DISPUTE REVIEW BOARD RECOMMENDATION

RE: SR 60A (Van Fleet Drive) from Agricola Road (CR 555) to SR 35 (US-98)
FIN No.: 197168-1-52-01
County: Polk

Issue – MSE Wall Sidewalk Payment

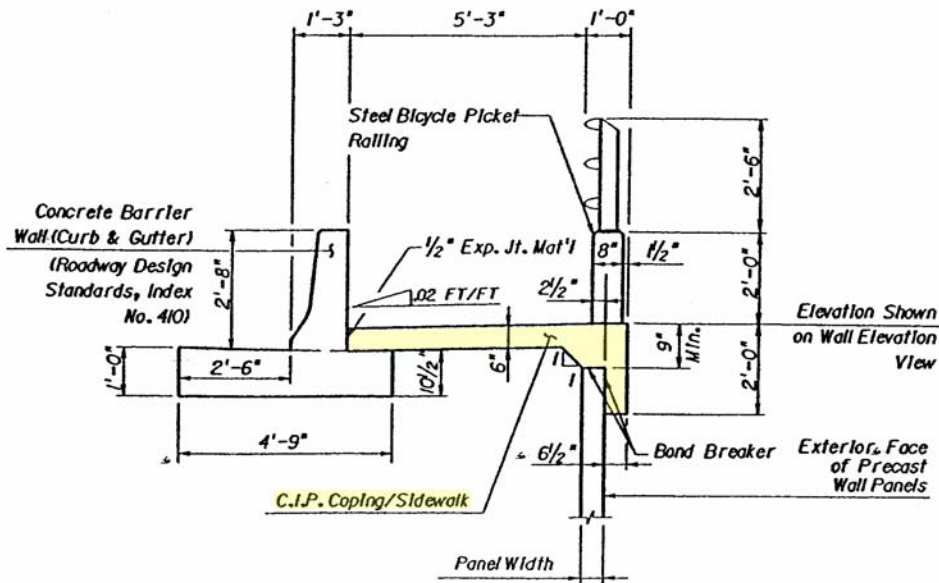
FDOT/PBCS Exhibit A (approved contractor shop drawing) is a detail of Type "CP24K_" Precast Coping/Parapet with sidewalk steel. The detail shows the precast coping/parapet with the sidewalk steel. A construction joint is shown with a cast in place 6" sidewalk. **This is not an appurtenance to the MSE wall, it is a separate 6" sidewalk with sidewalk steel.**

FDOT/PBCS Exhibits B & C are for a cast in place coping/sidewalk poured monolithically. As can be seen from FDOT/PBCS Exhibit A this is not what was to be constructed. **A precast coping/parapet with a 5' cast in place 6" sidewalk was to be constructed.** The notes on this page pertaining to the concrete being Class IV, 5500 psi do not pertain to this separate 6" sidewalk.

FDOT/PBCS Exhibit D (Index 5000, note 2) references cast in place appurtenances, i.e., coping, traffic railing barriers, sidewalk parapets, light pilasters, integral sign foundations, etc. **This is not a sidewalk parapet, it is a cast in place sidewalk.**

WALL/SIDEWALK DETAIL @ STANDARD ROADWAY SECTION
(Right Side)

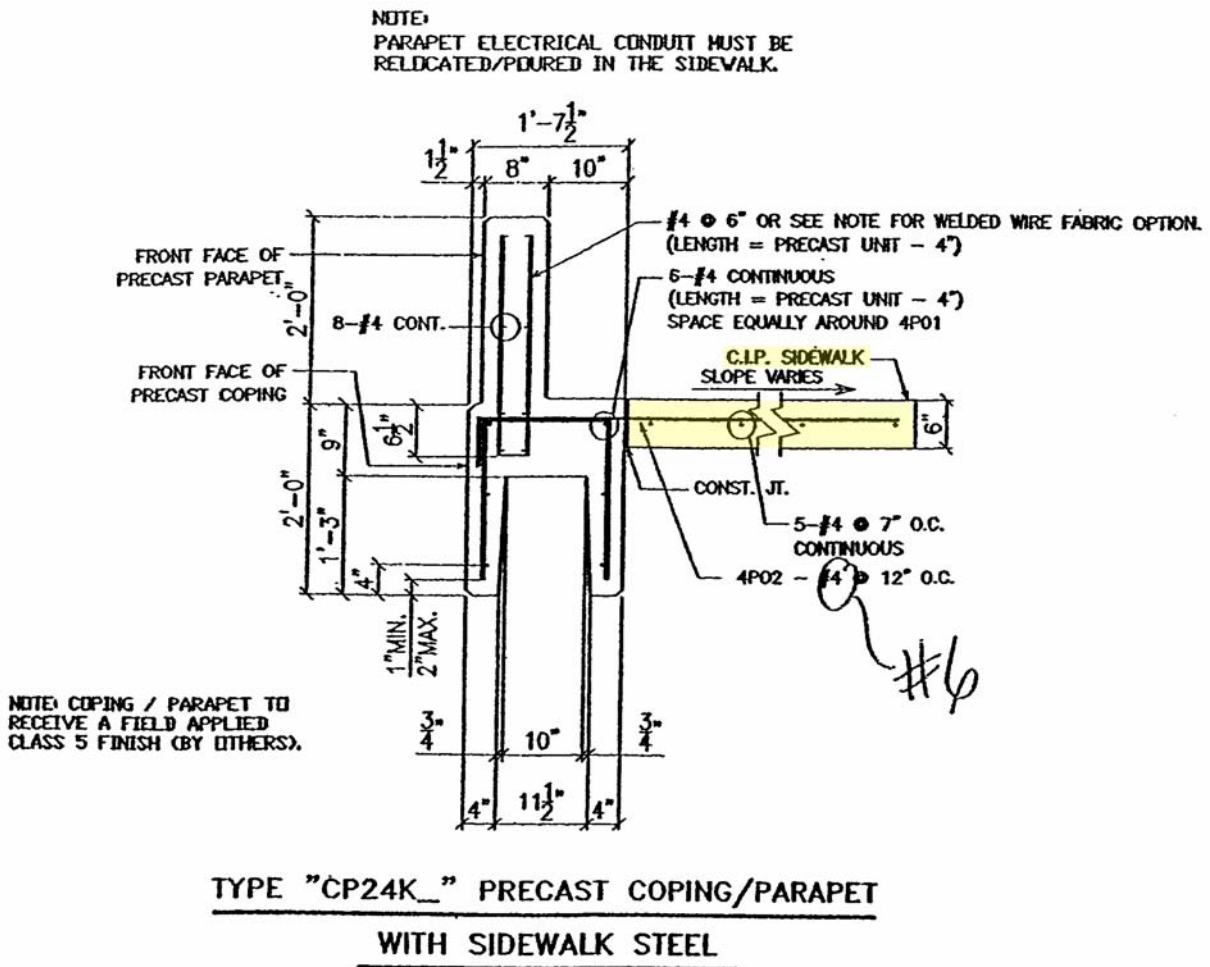
- CONTROL DRAWING GENERAL NOTES INDEX NO. S-1410 included in the contract plans has the **detail below showing the sidewalk to be an integral part of the coping.**

Based on the materials supplied to the Board and presentations to the Board at the DRB hearing, **the Board recommends that there is no entitlement for the Contractor to be paid for 6" concrete sidewalk adjacent to the Retained Earth Wall under Item No. 522-2, Sidewalk Concrete (6") on the project.**
